**Date** February 11, 2008

**Re: Ingersoll Ave. Dahl's Foods Environmental and Energy Conservation Measures**

P.U.D. CONCEPT PLAN  
DAHL'S FOODS  
3425 INGERSOLL AVENUE

P.U.D. CONCEPT PLAN  
**DAHL'S FOODS**  
 3401 INTERSTATE AVENUE

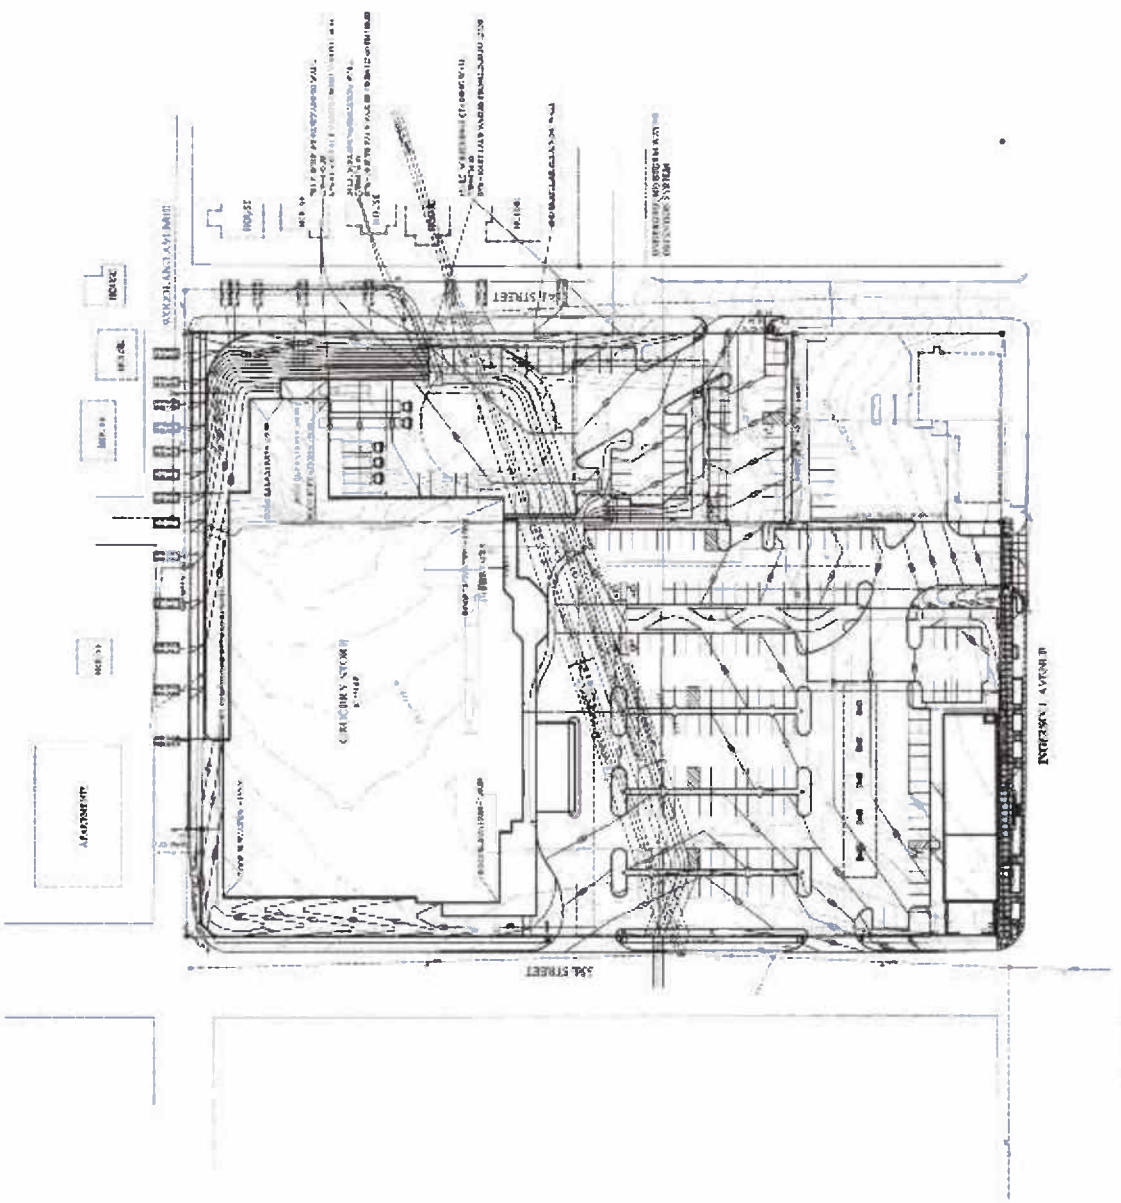
4. All existing and proposed public easements shall be identified on the PUD Concept Plan.
5. A storm water management summary statement shall be provided on the PUD Concept Plan.

8. A public access easement must be provided for the portions of the sidewalk along Woodland Avenue that are located on private property.
9. Dahl's shall be responsible for improvements made to the 34<sup>th</sup> Street pavement as necessary to handle truck traffic and allow on street parking as determined at the PUD Final Development Plan stage. Upon final determination of the necessary improvements and costs, the City may consider the value of sanitary sewer and storm sewer easements in lieu of a portion of Dahl's obligation for costs to improve 34<sup>th</sup> Street.

FUEL CANOPY - EAST AND WEST ELEVATION

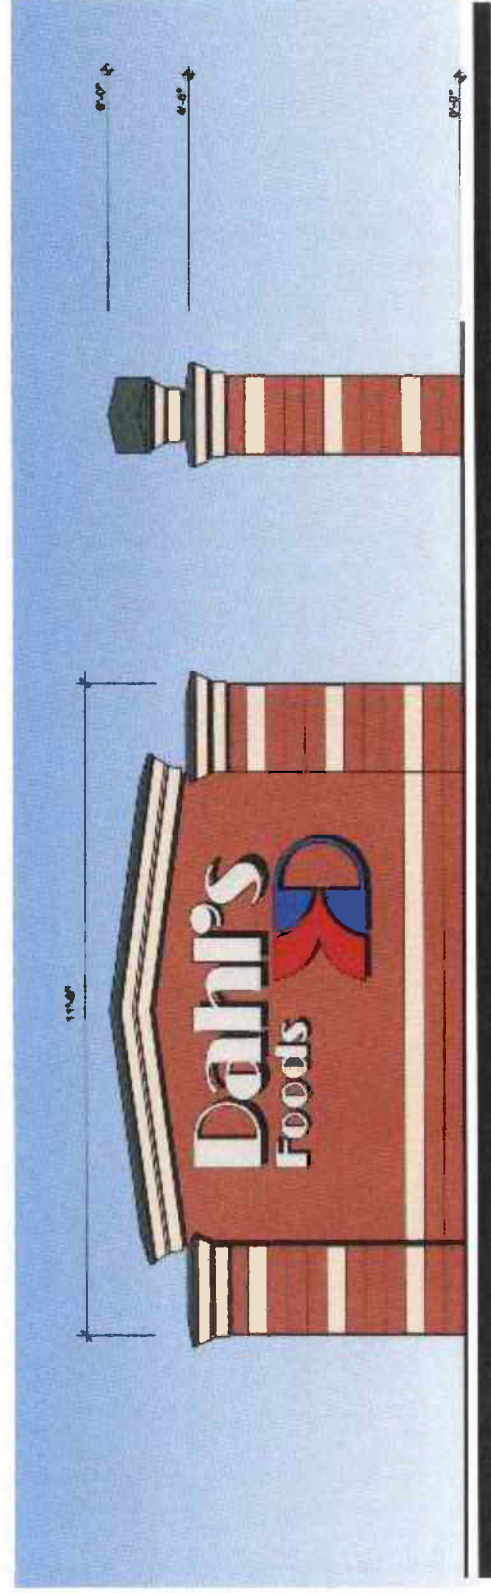
- o) Fuel pump canopy signage is prohibited.
- p) The fuel pump canopy support columns shall be enclosed with a masonry product that generally matches the convenience store.

- q) The minimum clearance height under the canopy shall be no less than 13 feet – 9 inches and the maximum canopy height shall not exceed 17 feet.
- r) All gas canopy lighting (including lenses) must be recessed within the canopy ceiling and the side fascia shall extend 12-inches below the canopy ceiling, except for directional spotlights pointed at the fuel pumps.
